| Subject: STOPPER PLATES FOR AIR BAG MODULE CONNECTORS HAVE BEEN ESTABLISHED AS NEW SERVICE PARTS | Service Alert No.: SA-068/17 |
| | Last Issued: 09/12/2017 |

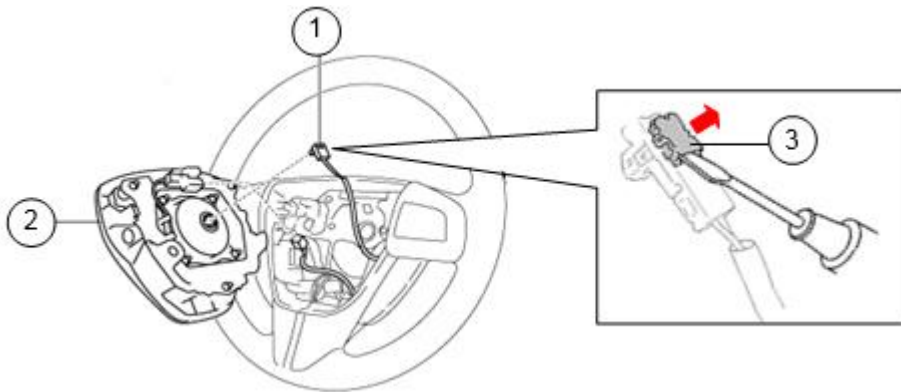
When removing the connector (1) to the air bag module (2), make sure to first lift the stopper plate (3) carefully using a flathead screwdriver (but do not remove it), and then pull out the connector.

- **Pulling out the connector without lifting the stopper plate will cause damage to the connector.**
- **If work is not performed carefully, the stopper plate may pop off/be damaged/become lost.**

In case that the stopper plate is damaged/lost during the recall work, the stopper plates have been established as new service parts. Two types of old and new stopper plates exist. The exact switching date from the old to new stopper plate is unknown. Confirm the configuration of the stopper plate used on the vehicle, then order one with the same configuration.

| Part Number | GAY1 67 022 | GAY2 67 022 |
| Description | Stopper Plate (OLD TYPE) | Stopper Plate (NEW TYPE) |
